Title: Advisory Committee on Reactor Safeguards
Subcommittee on AP1000 - Open Session

Date: Tuesday, October 5, 2010

**Westinghouse AP1000 Design Certification
Amendment Application**

**AFSER Section 6.4
Control Room Habitability Systems**

Regulatory Guidance

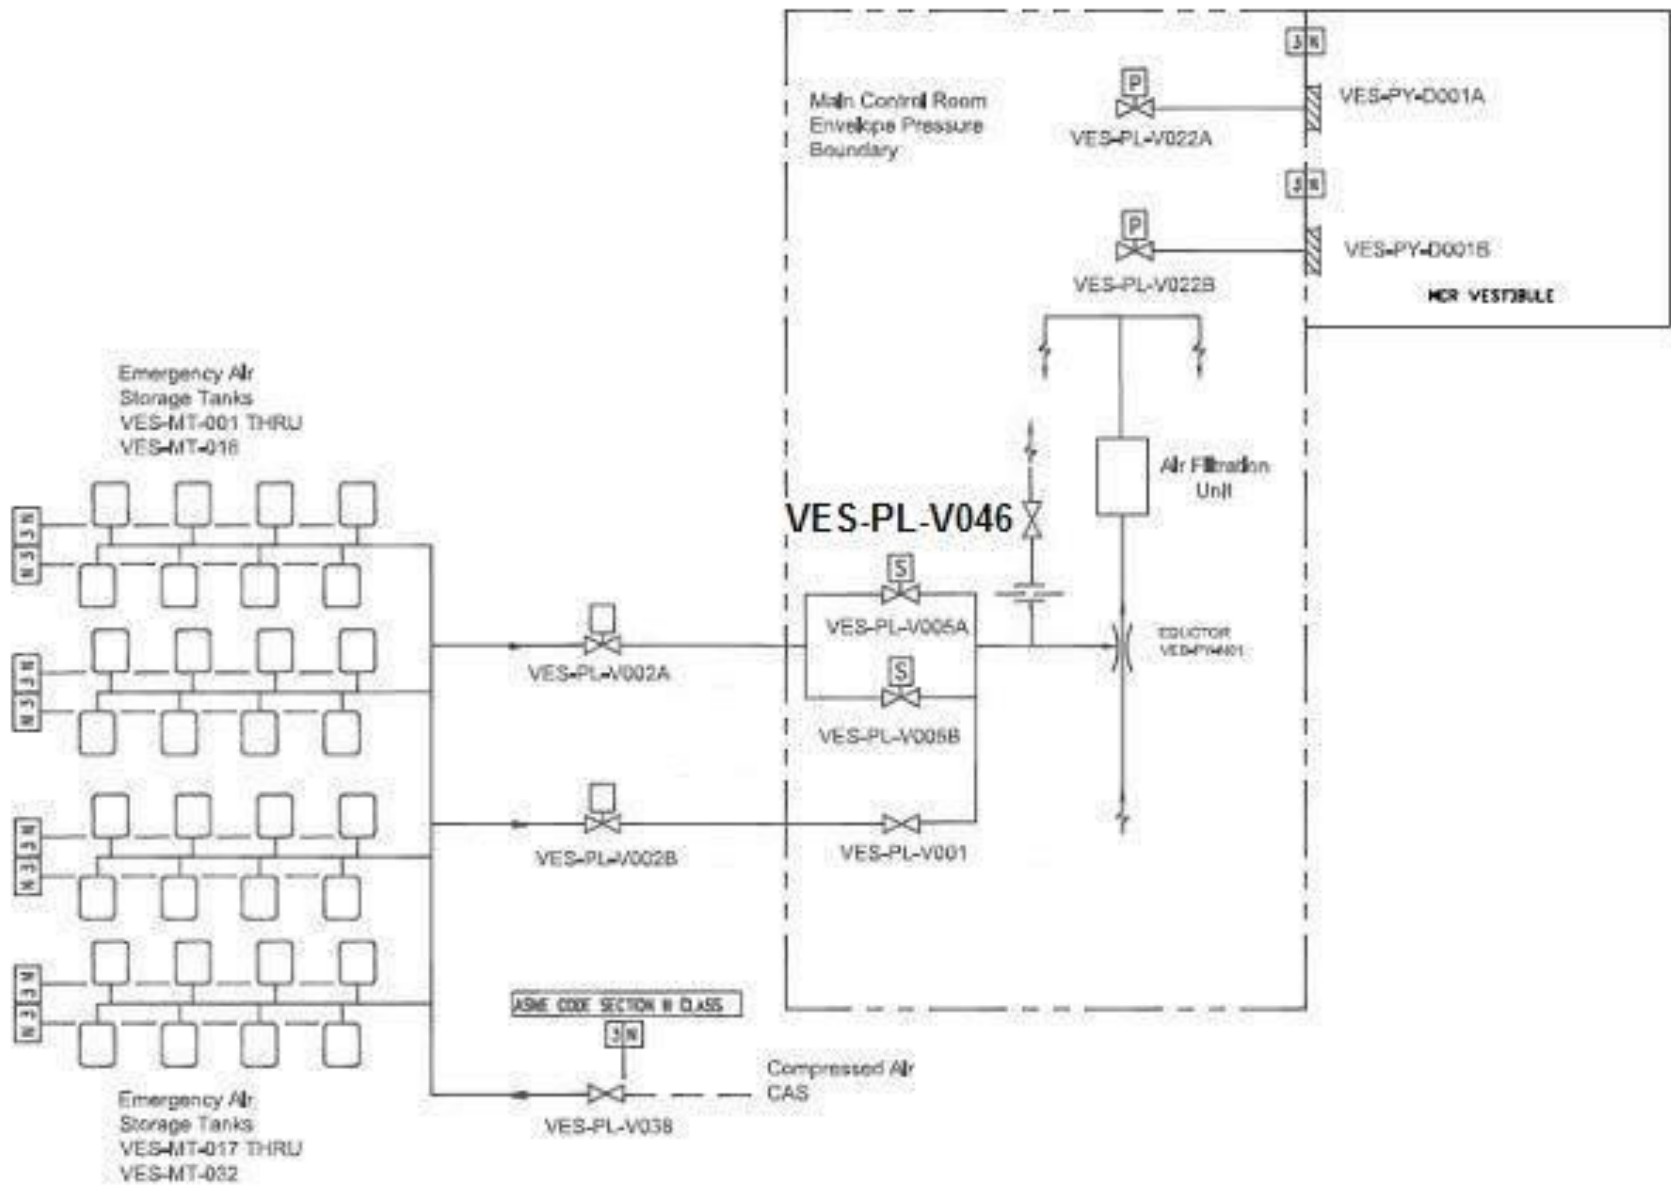
14 Third slide please. Regulatory guidance on
15 this. GDC 19 is the overarching requirement, which
16 covers control room habitability. We have SRP 6.4
17 addressing control room habitability. In this review
18 we used Reg Guide 1.52 for the safety related filters,
19 Reg Guide 1.197 for demonstrating control room
20 integrity.

21 We also have Reg Guide 1.195 and 1.196 on
22 dose analysis and habitability.
